# PlanGrid Task Report - Sep 12, 2025

Prepared by Stephen Tassinaro

28 tasks in this report.

## #493 [UNIT 499] [NEW] CRITICAL - RTU-1 Alarms

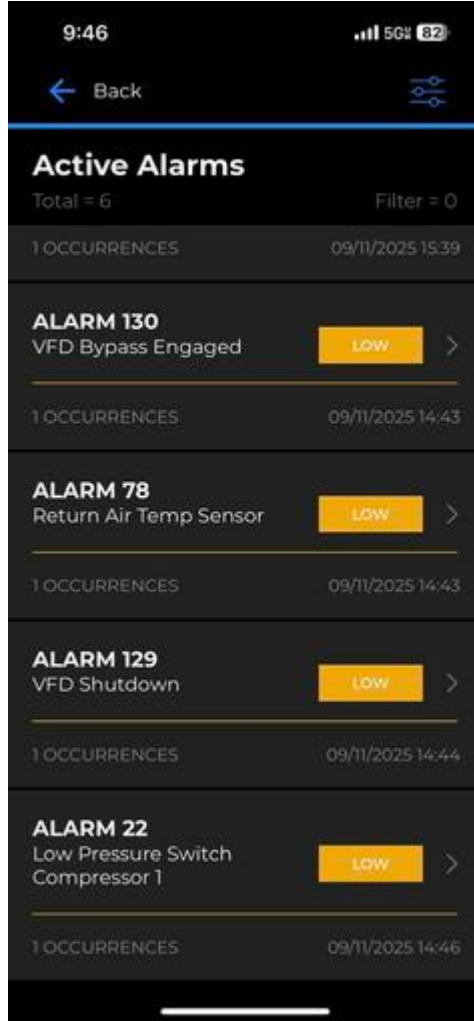
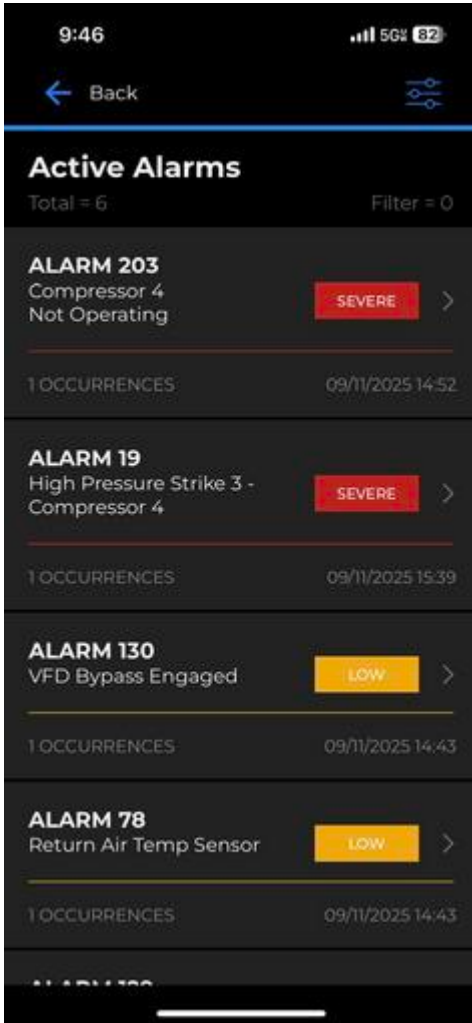
RTU-1 has multiple critical alarms concerning the VFD and compressors. VFD has been bypassed prior to NTi arriving on site.

## #492 [DUCT 006] [NEW] CRITICAL – Flex duct installation RTU-1

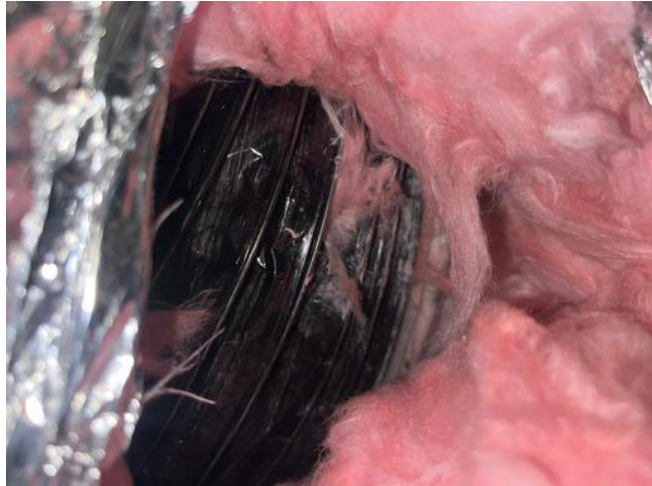
Ensure flex inner core is taped and banded, along with tape or banding on outer insulation jacket.

### #490 [CNTL 017] [NEW] CRITICAL Thermostat terminations incorrect.

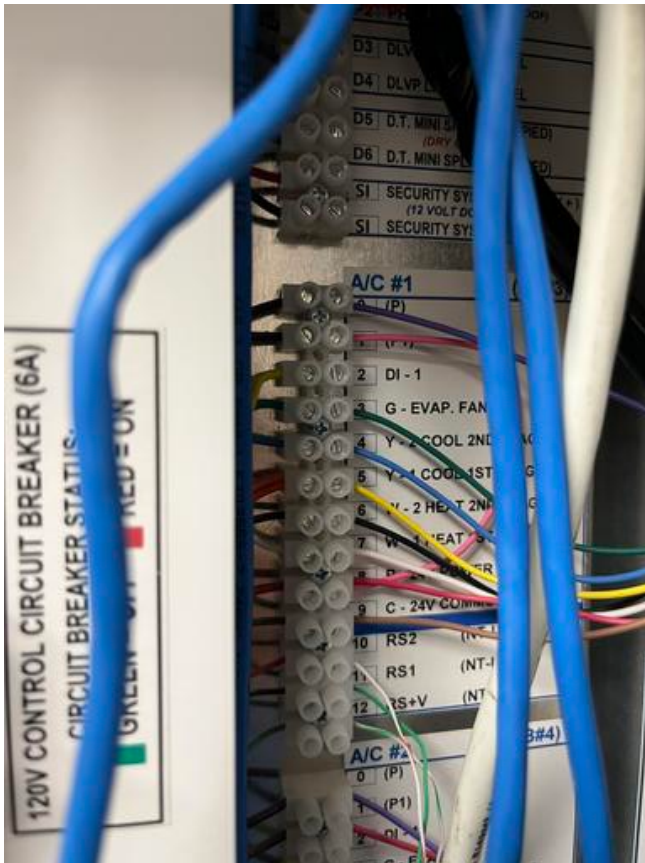
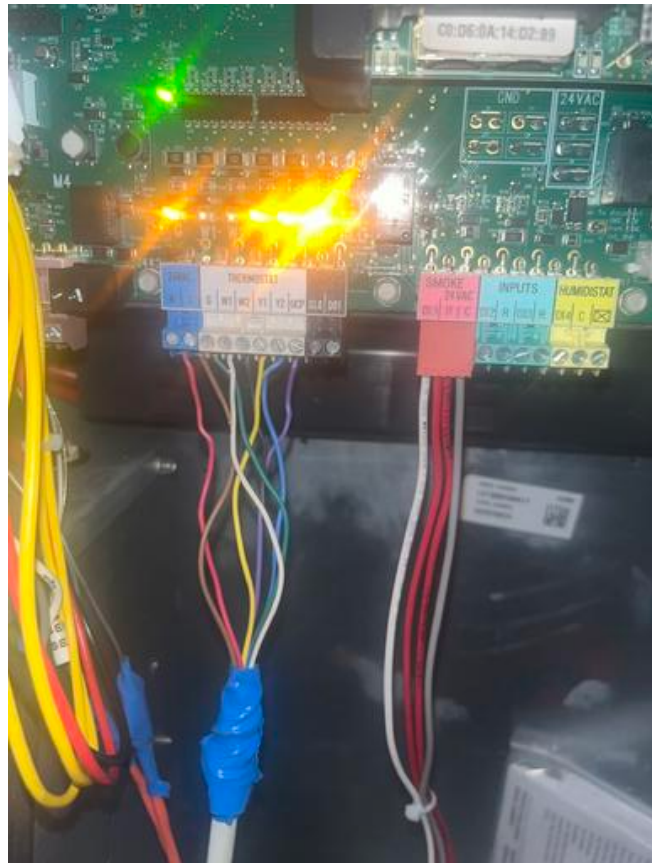
D1 terminals not landed.

# #317 [EXHA 001] [NEW] CRITICAL – Grease duct access doors.

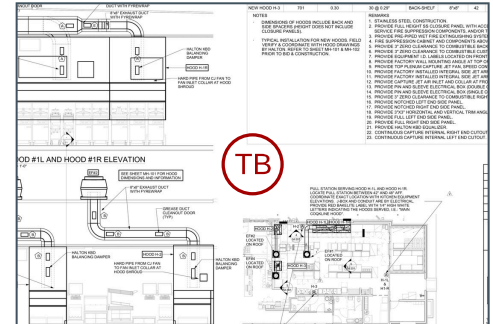
**Description**  
Total number of access doors installed per grease duct is less than that shown on MSET.

Attached photo is of Hood 3 grease duct, recommend verifying all grease ducts have correct access panels.

## #310 [CNTL 504] [NEW] Wire / cable management.

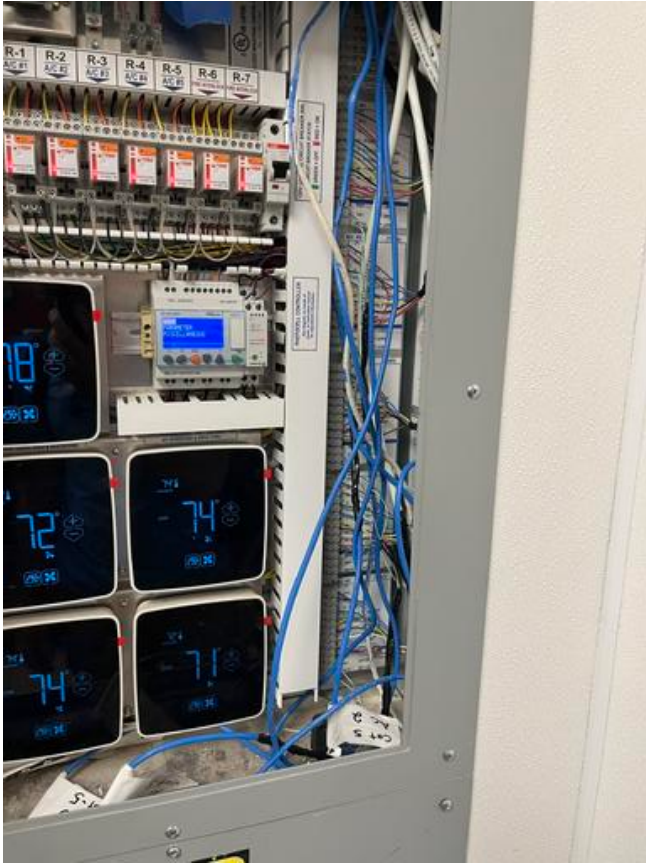
Wiring does not use correct cable management and is at extra risk of damage (beam clamps+bridal rings, wire loops for future service, runs perpendicular or parallel to structure supports).

Unresolved.

## #284 [UNIT 514] [EXIST] Equipment gas piping.

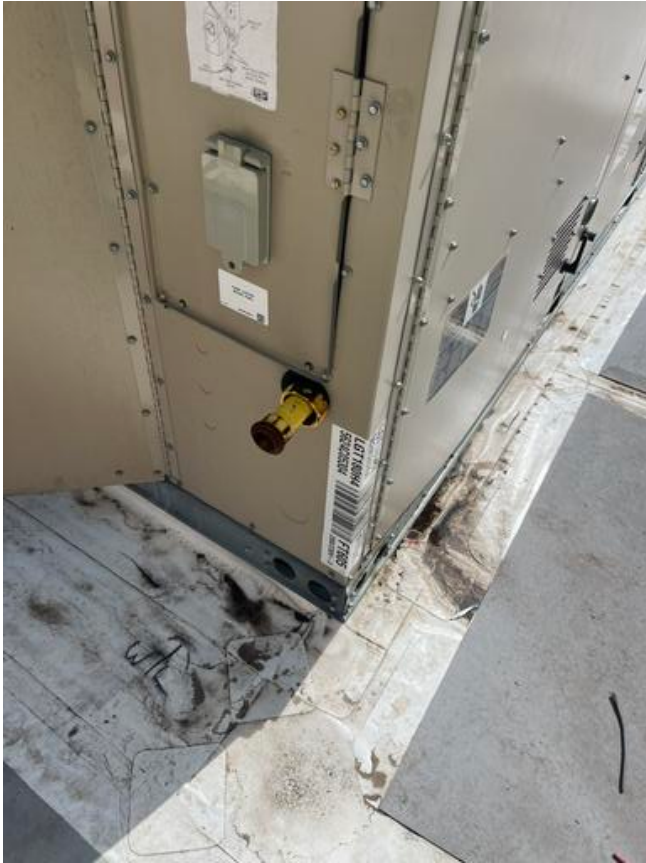
Equipment gas piping is not completed.

Task re-opened. All gas valves in closed positions.
